**Lee Nuclear Station Units 1 and 2  
Description, Scope of Changes, and FSAR Impacts due to Plant Relocation and  
Additional Design Enhancements**

**Description and Rationale for Lee Nuclear Station Units 1 and 2 Relocation and  
Additional Design Enhancements**

FIGURE 2.4.4-201

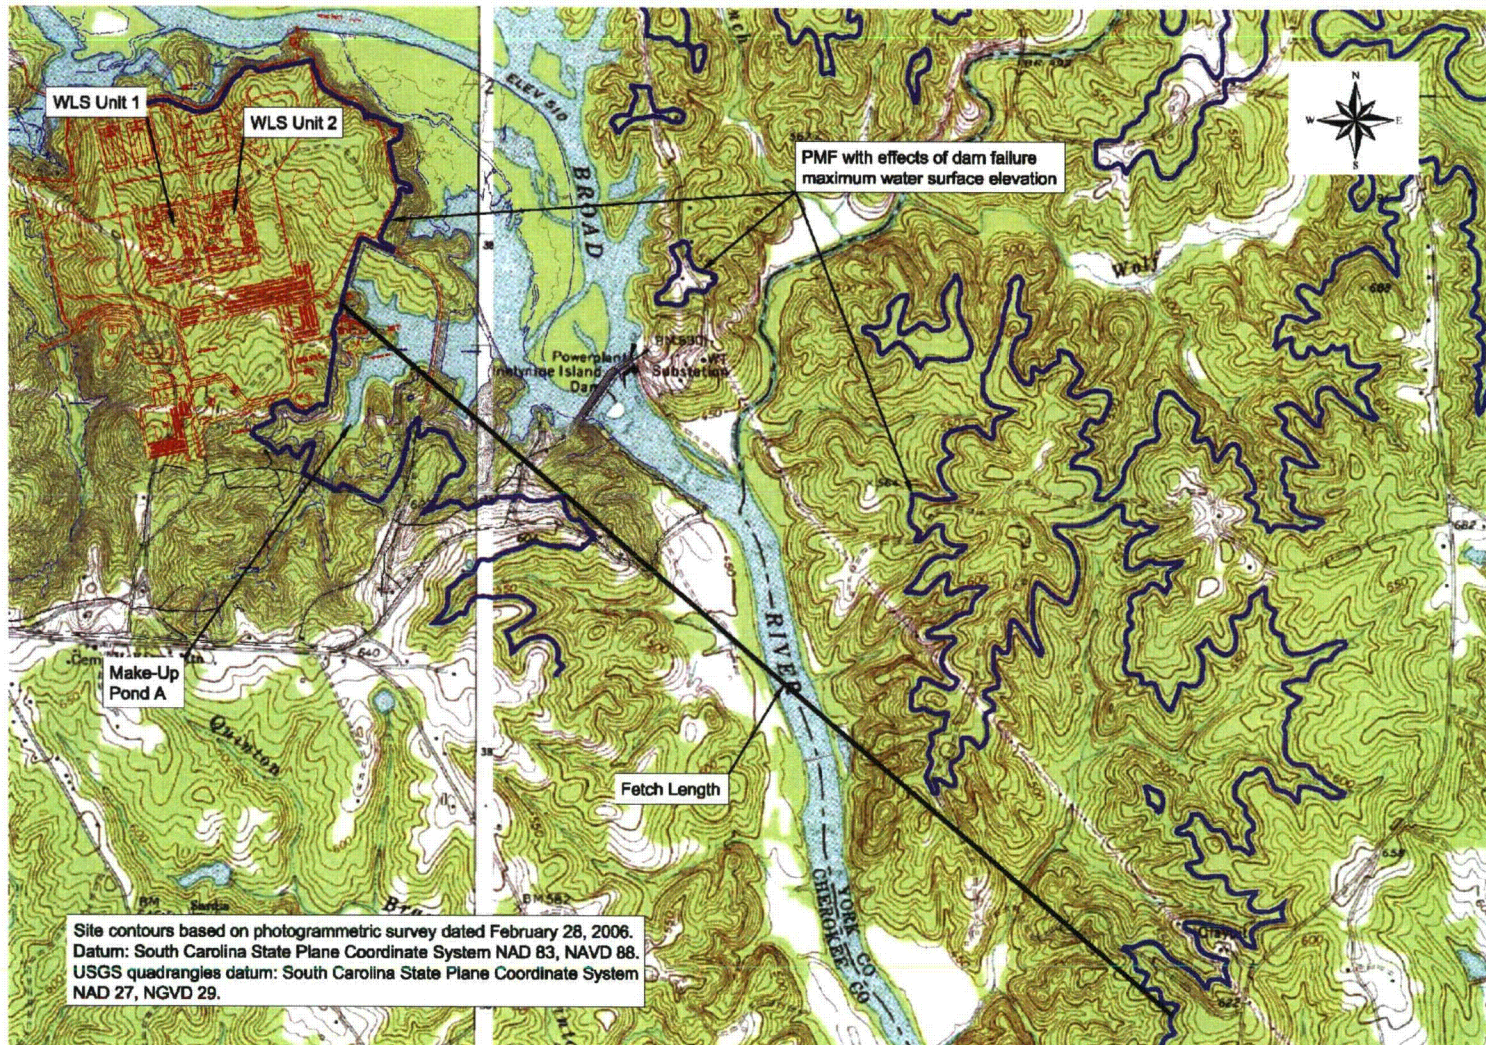
Wind wave activity on the Broad River is evaluated coincident with the maximum water surface elevation of the PMF including the effects of dam failures as discussed above. The determined fetch length of 2.77 mi., shown in Figure 2.4.4-201, has a runup slope of 40 percent. The PMF including effects of dam failures and the coincident wind wave activity results in a flood elevation of 584.79 ft. msl. The Lee Nuclear Station safety-related plant elevation is ~~590~~ 593 ft. msl and is unaffected by flood conditions and coincident wind wave activity. A more critical wind wave activity result was determined considering a fetch length through Make-Up Pond A, which becomes inundated by backwaters of the Broad River during severe flooding events. Therefore, the critical wind wave activity for the Broad River is equal to the wind wave activity for Make-Up Pond A, as discussed below.

60. COLA Part 2, FSAR Chapter 2, Figure 2.4.4-201 is revised as follows:

FIGURE 2.4.4-202

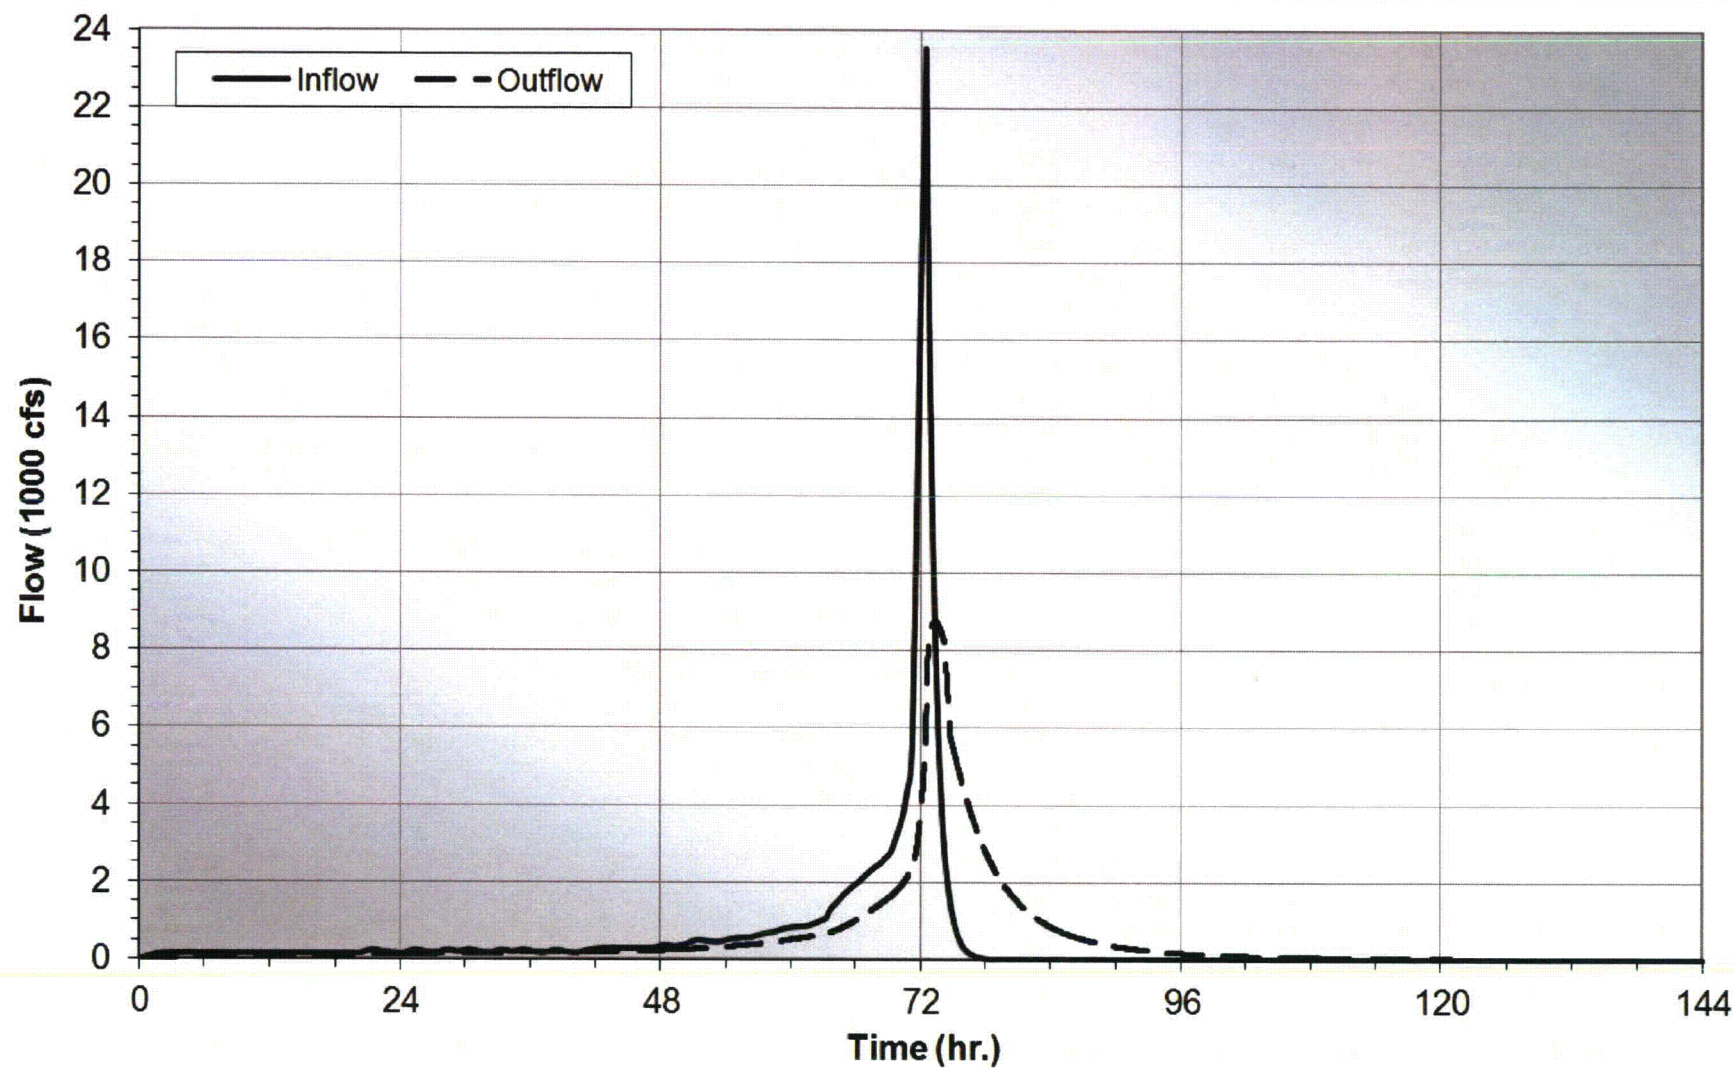
61. COLA Part 2, FSAR Chapter 2, Figure 2.4.4-202 is revised as follows:

FIGURE 2.4.4-203

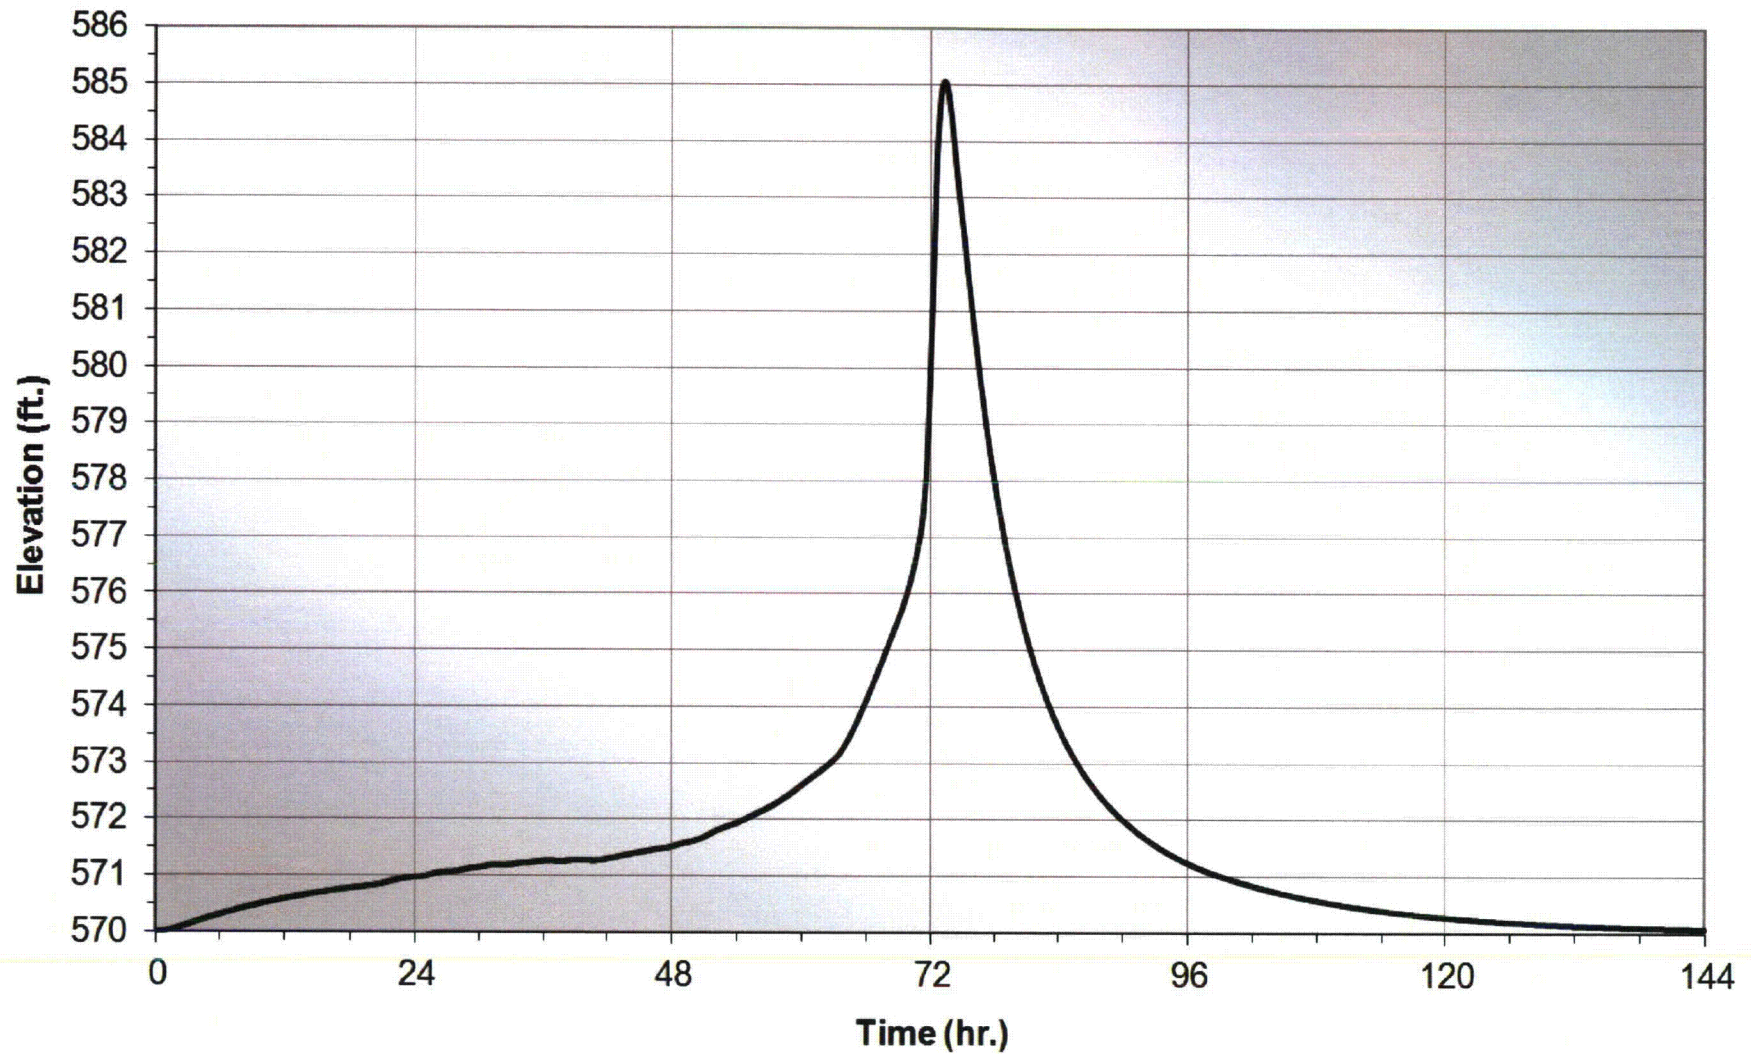
62. COLA Part 2, FSAR Chapter 2, Figure 2.4.4-203 is revised as follows:

FIGURE 2.4.4-205

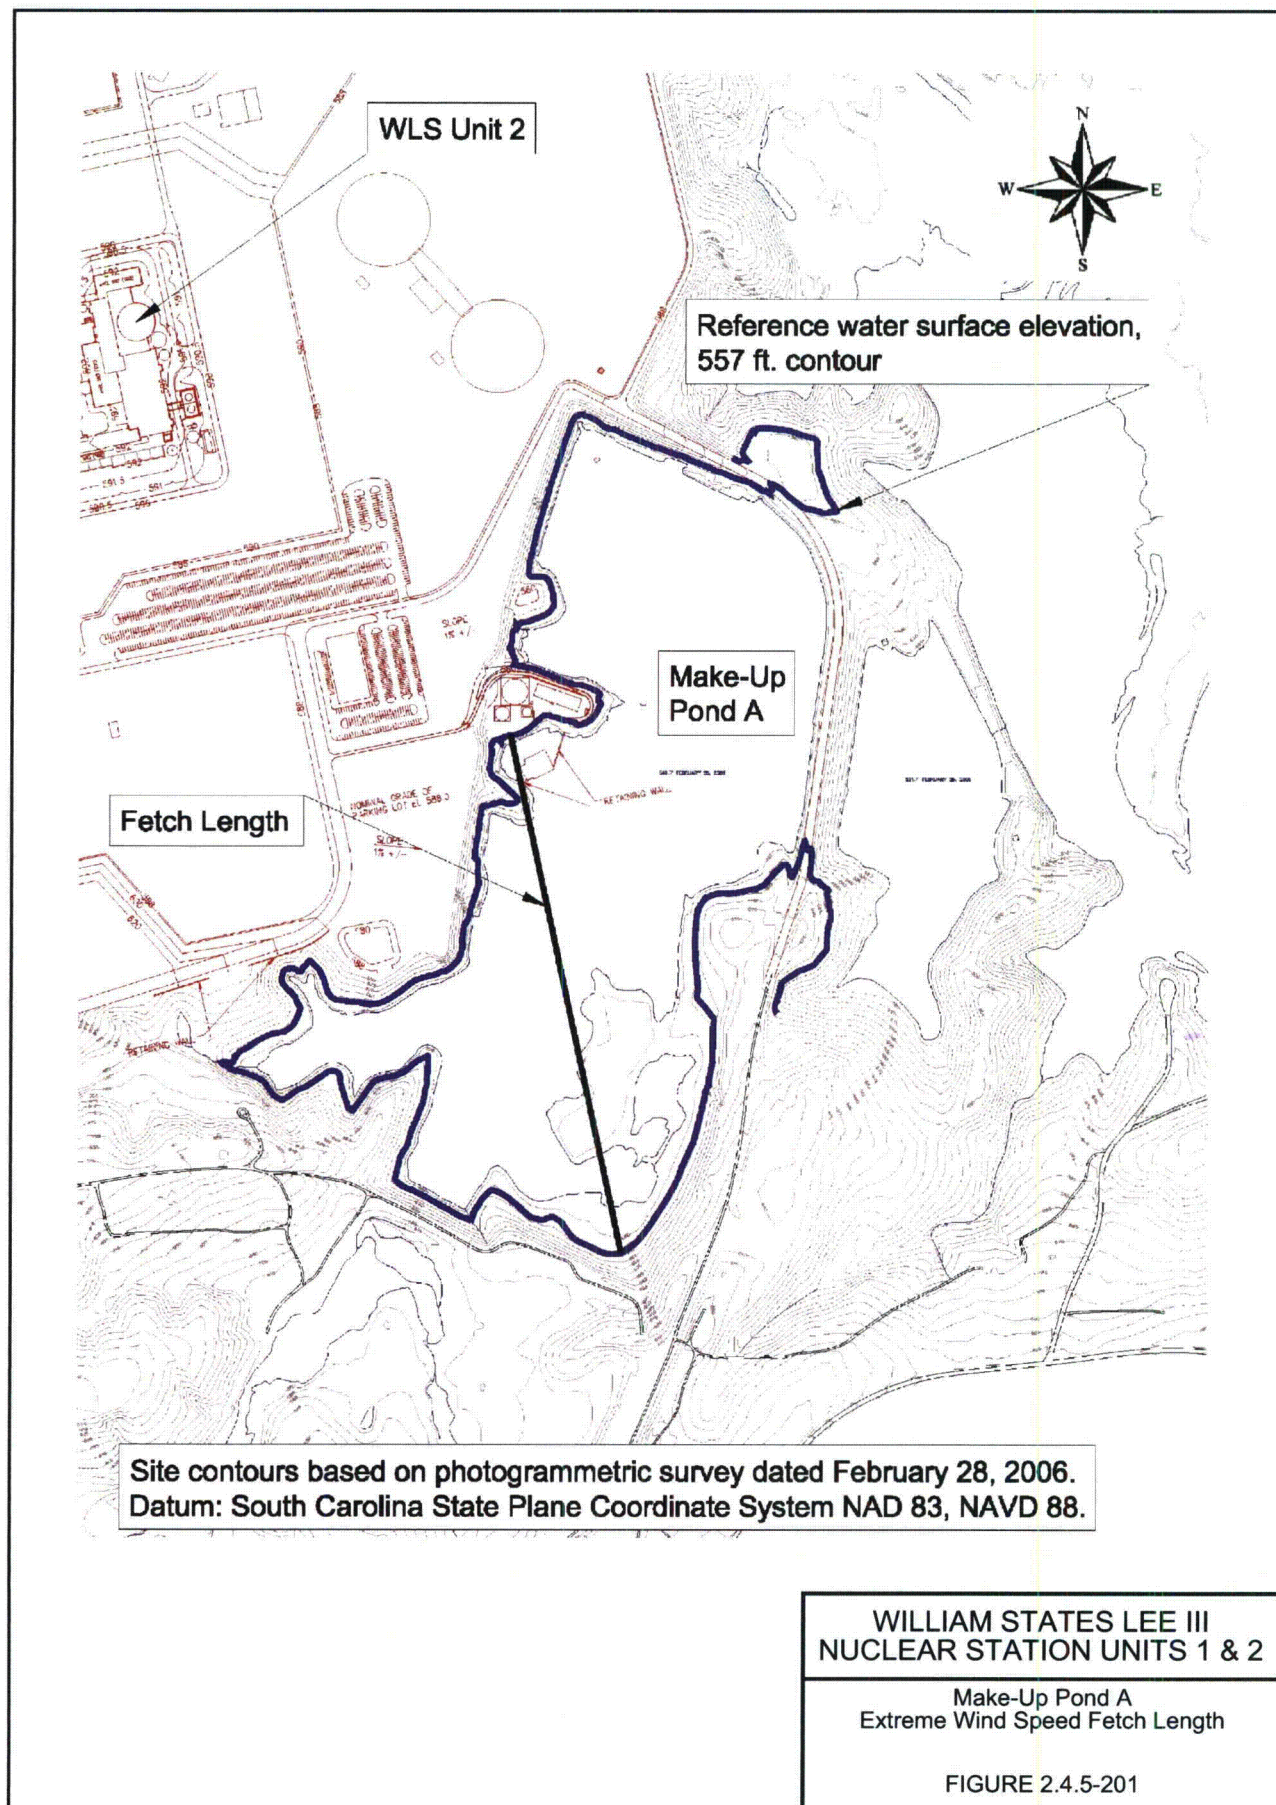
63. COLA Part 2, FSAR Chapter 2, Figure 2.4.4-205 is revised as follows:

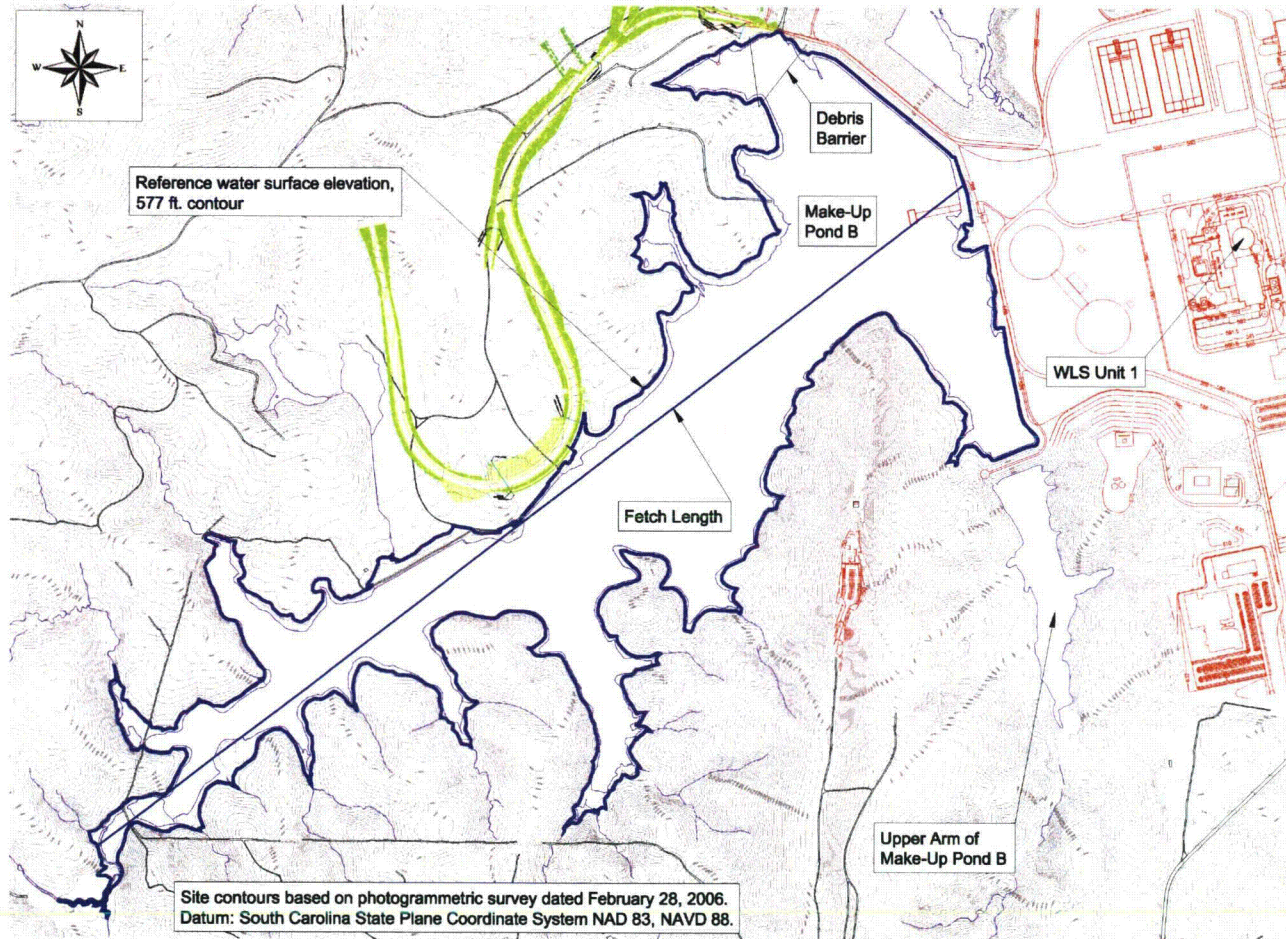
Make-Up Pond A surge flooding is evaluated coincident with the 100-yr. water surface elevation of ~~556.07~~556.08 ft. The critical fetch length is ~~0.36~~0.39 mi. as shown in Figure 2.4.5-201. The wind speed is adjusted based on the factors of fetch length, level overland or over water, critical duration, and stability using U.S. Army Corps of Engineers guidance (Reference 295). The critical duration is ~~40~~11 min. The adjusted wind speed is ~~97.4~~92.7 mph.

64. COLA Part 2, FSAR Chapter 2, Figure 2.4.5-201 is revised as follows:
